Item Name: Crosstube Fwd High

DART AEROSPACE LTD	Work Order:	99872
Description: Crosstube High Fwd (205/212/412)	Part Number:	D212-664-101
Inspection Dwg: D212-664-141 Rev: D		Page 1 of 1

D212-664-141/-141B
ASSEMBLY DETAIL

DRAWING NO. D212-664-141	TITLE XTUBE ASSY (205/212/412 HI FWD)	REV. D	DART AEROSPACE LTD ENGINEERING ORDER		D.E.O. NO. D212-664-141-D-1	SHEET NO. SHEET 1 OF 2	SCALE NTS
DRAWN	CHECKED	MP	MFG. APPR.	APPROVED	MP	DE APPR.	
DATE 11.04.07	DATE 11.04.11		DATE 11.04.12	DATE 11/04/12		DATE 11.04.12

DRAWING NO. D212-664-141	TITLE XTUBE ASSY (205/212/412 HI FWD)	REV. D	DART AEROSPACE LTD ENGINEERING ORDER	D.E.O. NO. D212-664-141-D-1	SHEET NO. SHEET 2 OF 2	SCALE NTS
DRAWN	CHECKED	MFG. APPR.	APPROVED	DE APPR.		
DATE 11.04.07	DATE 11.04.11	DATE 11.04.12	DATE 11/04/12	DATE 11.04.12

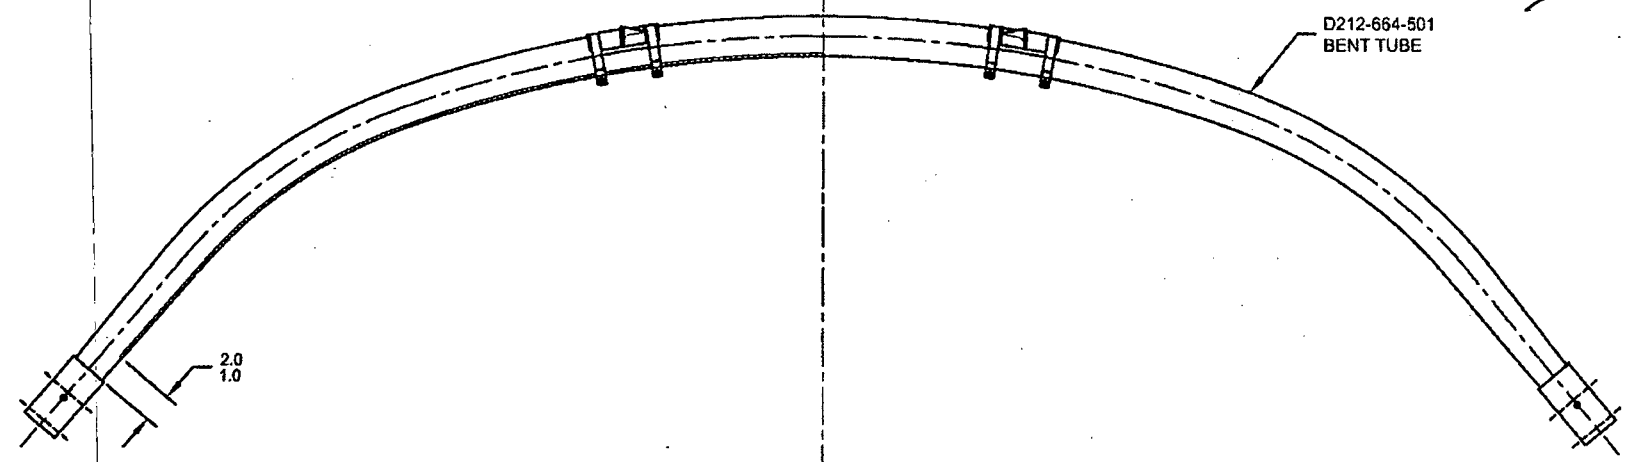
ADD AN INSPECTION WINDOW TO UNDERSIDE OF CROSSTUBE.

NOTES 2 OF SHEET 1 IS AMENDED AS FOLLOWS:

IS:

WAS:

MASK AREA PRIOR TO PAINTING.
REMOVE MASKING AFTER PAINT
AND APPLY CLEAR COAT

- 2) FINISH: CHEMICAL CONVERSION COAT PER DART QSI 005 4.1
PRIME INSIDE AND OUTSIDE PER DART QSI 005 4.2
MASK UNDERSIDE OF CROSSTUBE AS SHOWN (HATCHED AREA) AND
PAINT OUTSIDE PER DART QSI 005 4.2
REMOVE MASKING AND APPLY CLEAR COAT
